MEETING TITLE: Project Sponsors Council and Integrated Project Sponsors Council Staff Workshop
DATE: Friday, July 16, 2010
TIME: 10:00 a.m. – 12:30 p.m.
LOCATION: Washington State Department of Transportation, SW Region
 11018 NE 51st Circle, Vancouver, Washington 98662

WORKSHOP: Columbia River Crossing (CRC) Project Sponsors Council and Integrated Project Staff

**Public Comments Addressed to
CRC Project Sponsors Council
June 25, 2010 – July 15, 2010**

PHASE I
CONSTRUCT BRIDGE & ACTIVATE UPPER DECK

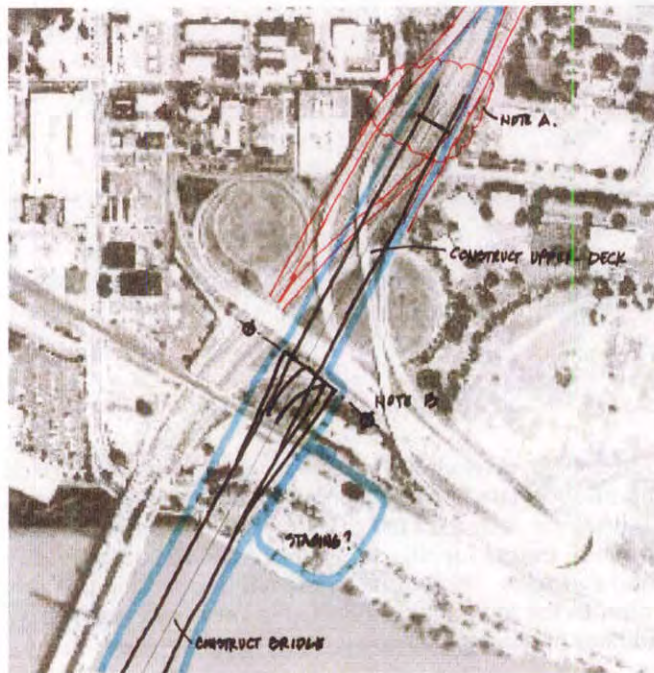
The first phase might involve construction of the bridge to a point where the existing I-5/SR-14 interchange limits continuation of the lower deck. This is represented in the following schematic:

In this picture the lower level is completed to the south edge of SR-14. This is called 'note A'.

'Note B' is the interface between the existing, or improved, I-5 north of 7th. When construction of the upper deck interferes with I-5 it may be necessary to accept temporary widening of the freeway with temporary lanes to the outside of the 125 foot wide 6 through lane upper deck. If three temporary lanes are provided outbound of the center 125 foot wide upper deck connection the total width need at this location may be 260 to 280 feet wide.

PHASE II
CONSTRUCT SR-14 / VANCOUVER INTERCHANGE

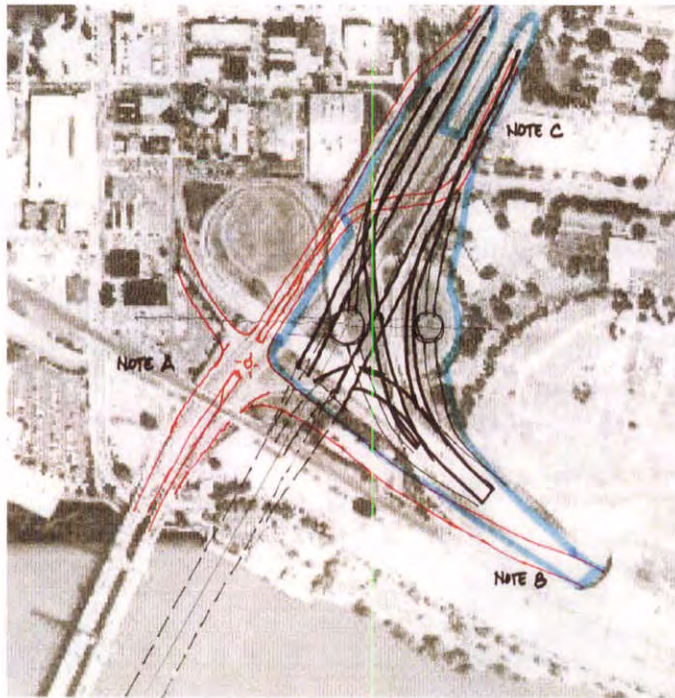
Phase two starts with through traffic moving across the upper deck. At this time the need is to connect SR-14 traffic with I-5 and allow access to Vancouver from I-5 and SR-14. With greatly reduced traffic flows in this construction area a signaled intersection just north of the BNSF bridge allows SR-14 and Vancouver traffic to cross while the old bridge continues to operate.

In this picture a large triangular area, shown in blue, is available for construction of the lower deck and SR-14 ramp. 'Note A' is where a temporary signaled intersection exists between SR-14 and Vancouver traffic. 'Note B' is where SR-14 traffic is routed off the existing road to a temporary pavement running on the north side of the BNSF berm. Ideally, the interface between new and old SR-14 occurs just west of the pedestrian overpass. 'Note C' is where NB I-5 merging traffic will need to route within the construction area as the lower deck is built. It's very likely that this NB I-5 ramp will need to shift location a number of times as the lower deck is constructed.

Phase II may require six months to complete suggesting that the existing I-5 bridge continues in use during this period. However, the total construction period is likely to be less than what is needed with the WSDOT/ODOT two bridge preferred alternative as only one bridge is needed with the straight alignment. Assuming the first bridge takes 2.5 years and the second bridge 2 years the WSDOT/ODOT bridge may require 4.5 years total duration to build. The straight alignment bridge may require 3.5 years to construct the more complicated bridge and one half year for the SR-14 phase II construction for a total construction period of 4 years. This is one half year less than the WSDOT preferred alignment.

N.B. PEAK HOUR
 WITH LOWER DECK COLLECTOR/DISTRIBUTOR
 FROM MLK TO SR-14 - "THE BRIDGES"

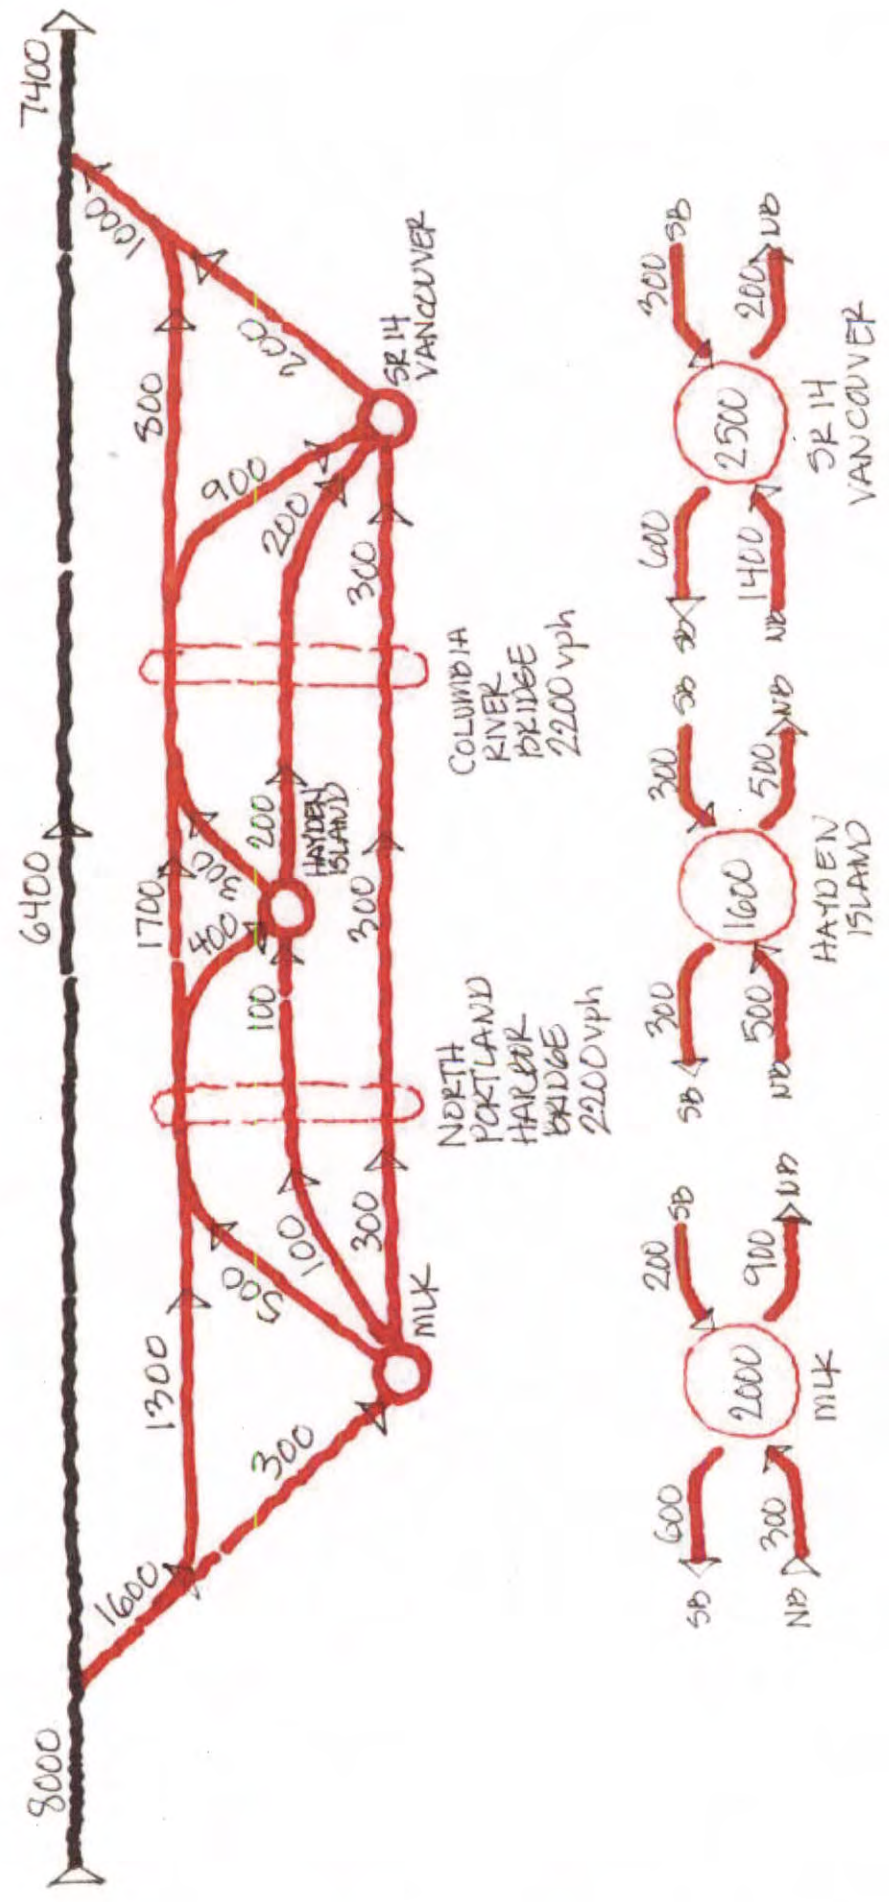
When we met the capacity issue of the collector distributor was questioned. I've been able to compare/interpolate the traffic technical report with information I used when exploring the validity of using two lanes for the collector distributor. The attached diagram is my best guess at intersection needs for MLK, Hayden Island and SR-14/Vancouver CBD intersections and resultant demand for the collector distributor. As the values on the diagram are an interpolation it would be very beneficial to have this reviewed by the transportation planner.

1. I assumed that 8,000 vehicles per hour are indicative of desired design capacities for NB movements just to the south of MLK. This is something like 25% more than accommodated this last decade. This suggests that south of MLK a four lane NB freeway is sensible – but I'd push for four wide lanes that can be retrofitted to five lanes.
2. Intersection volumes are taken from the Traffic Technical Report. SB/NB appropriations of these estimates are an assumption on my part. This assumption is where traffic planners will likely find errors and I encourage taking a critical position with respect to these movements.

1. Both river crossings appear to need a collector/distributor (CD) capable of moving 2,200vph. Using 'Expressway Lane' capacity of 1,100vph to 1,200vph per lanes the lower NB deck needs two lanes.

2. A 6,400vph need on the upper deck is accommodated in three lanes assuming freeway lane capacities are in the 2,000vph to 2,300vph range.
3. AT SR-14/Vancouver CBD my look suggests that 1,300vph to 1,500vph NB I-5 CD egress movements should be considered. This suggests two lanes as I think the capacity of the sweeping turn is in the range of 600vph to 700vph per lane. My guess is that 20% to 25% of these movements might be headed to downtown Vancouver suggesting that two lanes to EB SR-14 to one lane to downtown Vancouver is a reasonable assumption at this time. (It might be wide to double check what is assumed in the WSDOT/ODOT 'preferred alternative'. The single lane tight loop WB SR-14 to SB I-5 might not be adequate).

4. With 1,000vph to 1,200vph merging into I-5 at the north end of the CD, combined with the slight uphill grade, it makes sense to maximize the merging distance with the upper deck I-5 traffic by continuing two lanes of the CD
